PICmicro[®] 18C MCU Family Reference Manual

PICmicro[®] 18C MCU Family Reference Manual Errata Sheet

Clarifications/Corrections to the Reference Manual:

The PICmicro[®] 18C MCU Family Reference Manual (DS39500A) correctly describes the function of the PIC18C MCU family of devices, except for the anomalies described below.

Figure 22-2: CAN bus in ISO/OSI Reference Model

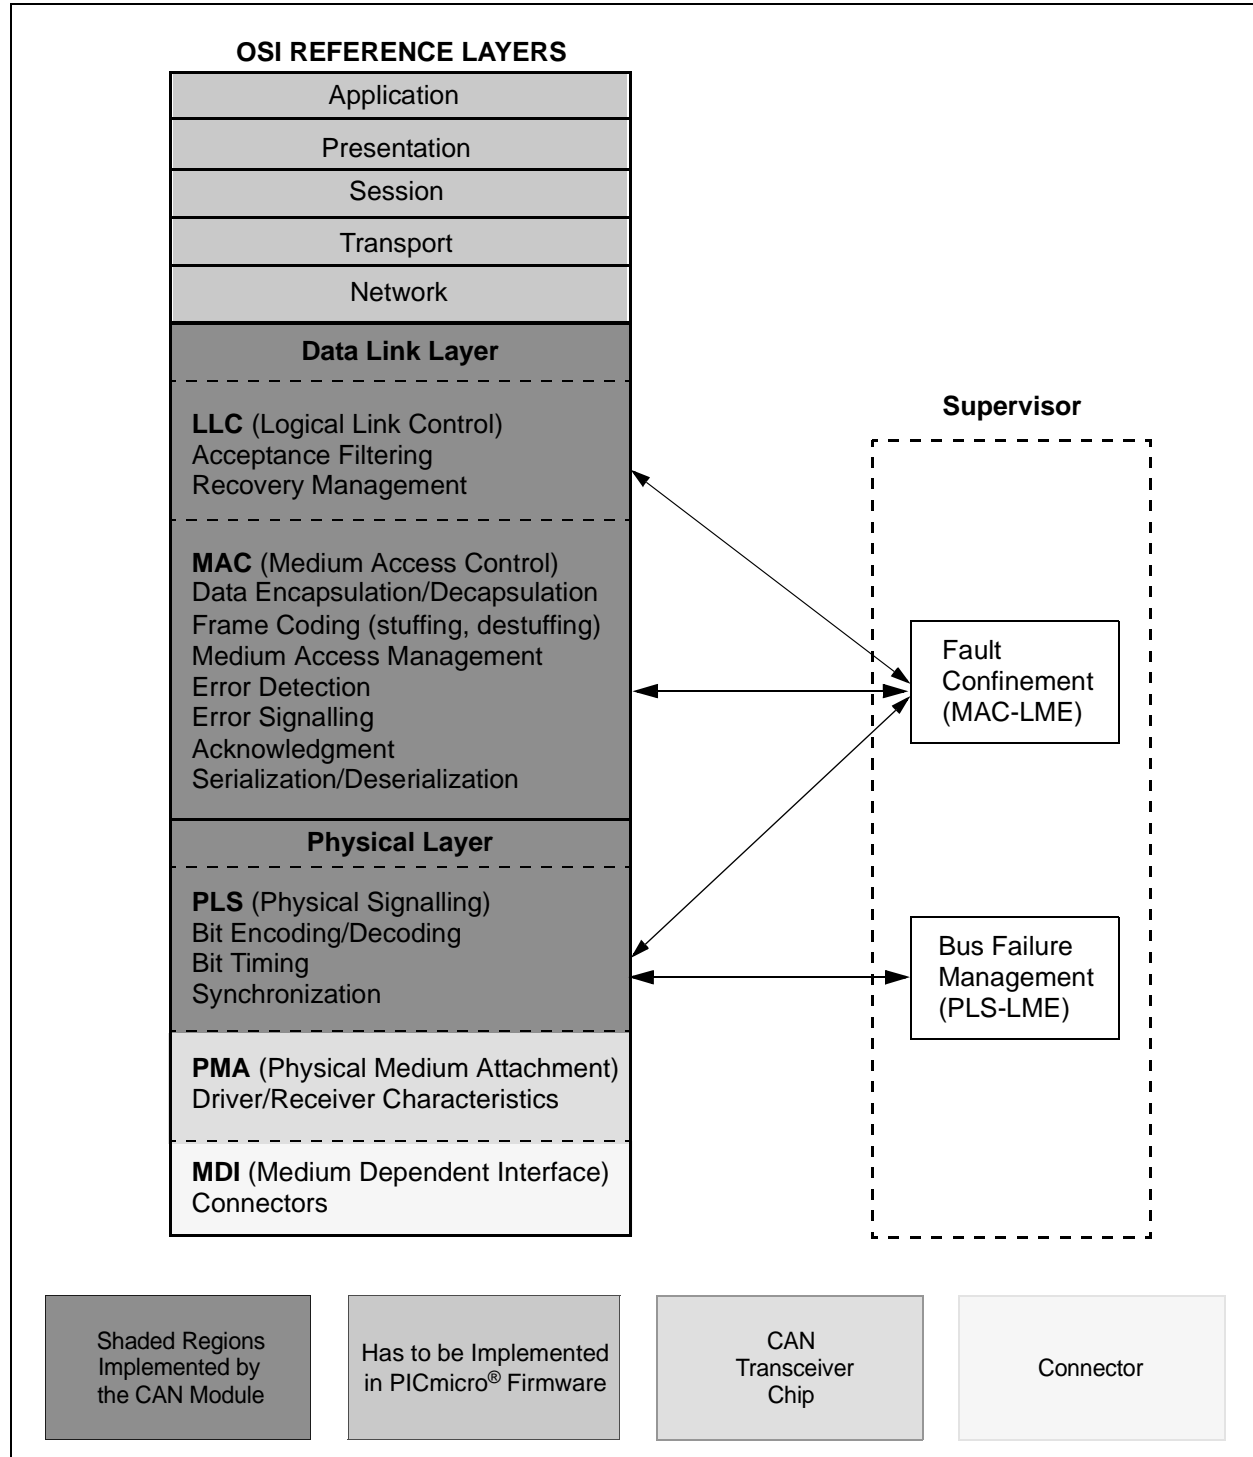
2. Page 22-31, Figure 22-2: CAN bus in ISO/OSI Reference Model

All references to Overload Notification, Overload Frame and Overload Flag have been removed from Figure 22-2: CAN bus in ISO/OSI Reference Model on page 22-31 and should be replaced with the following:

Figure 22-9: Error Frame

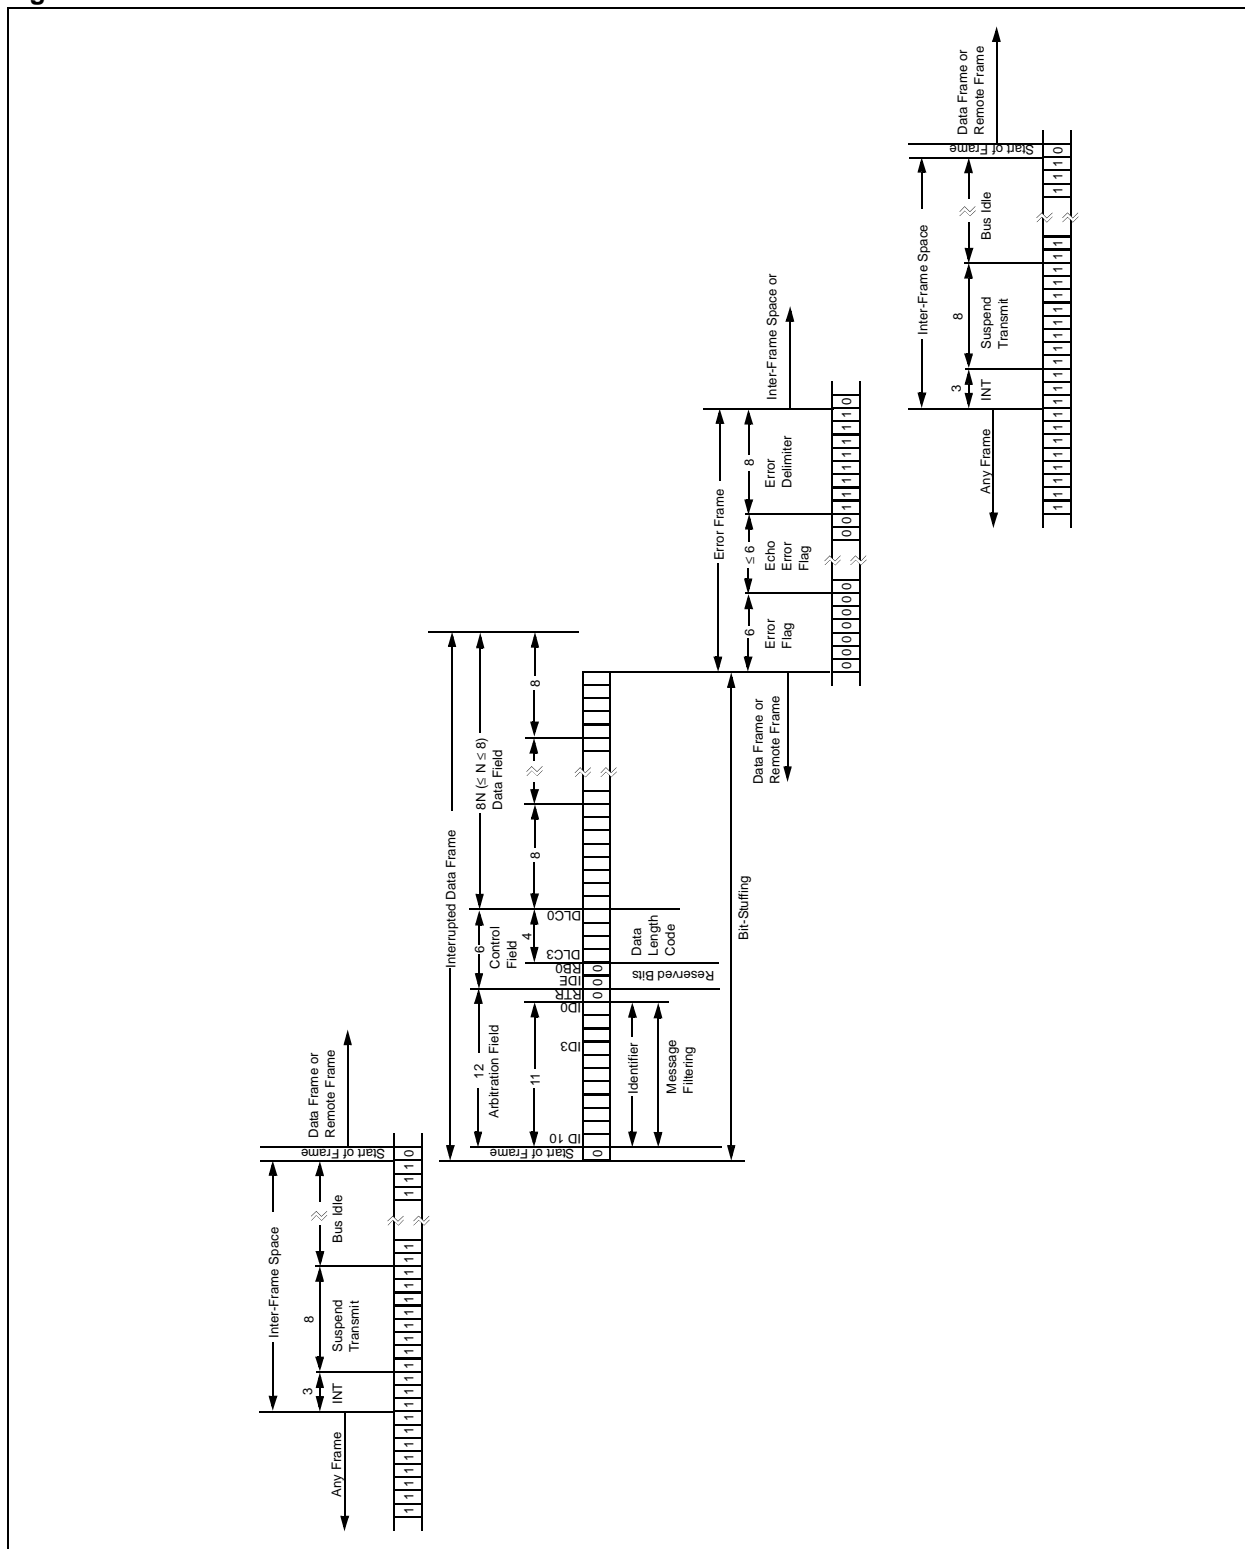
5. Page 22-42, Figure 22-9: Error Frame

All references to Overload Notification, Overload Frame and Overload Flag have been removed from Figure 22-9: Error Frame on page 22-42 and should be replaced with the following:
